**CORPORATION OF THE CITY OF NEW WESTMINSTER
BYLAW NO. 8515, 2025**

A Bylaw to Amend Subdivision and Development Control Bylaw No. 7142, 2007

1. This Bylaw may be cited for all purposes as “Subdivision and Development Control Bylaw No. 7142, 2007, Miscellaneous Amendments Bylaw No. 8515, 2025.”

Schedule 1 to Bylaw 8515, 2025

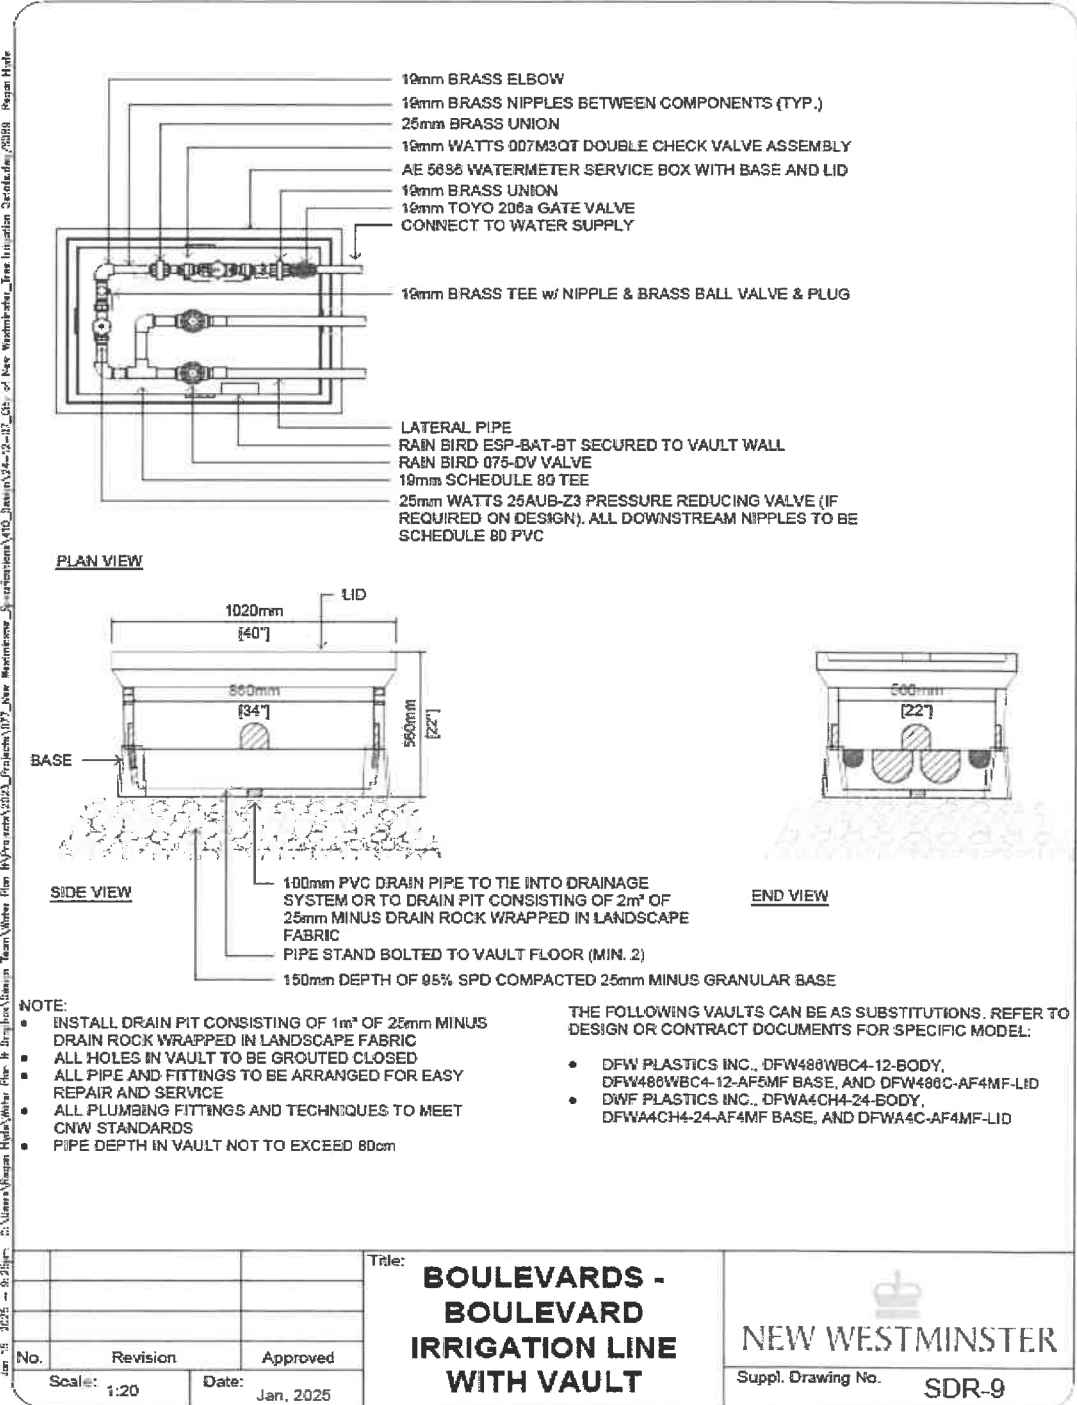
- o) In SCHEDULE "C" Section 3 Supplementary Detail Drawings:
 - i) Deleting Supplemental Drawing No. SDR-9 and replacing it with Schedule 1 attached to and forming part of this bylaw.
 - ii) Deleting Supplemental Drawing No. SDR-10 and replacing it with Schedule 2 attached to and forming part of this bylaw.
 - iii) Inserting Schedule 3 attached to and forming part of this bylaw between Supplemental Drawing No. SDR-10 and Supplemental Drawing No. SDR-11A.
 - iv) Deleting Supplemental Drawing No. SDR-12 and replacing it with Schedule 4 attached to and forming part of this bylaw.
- p) In SCHEDULE "D" Section Cover Page
 - i) On the Section Cover Page, adding SCHEDULE "D" before "Engineering Department Drafting Standards"
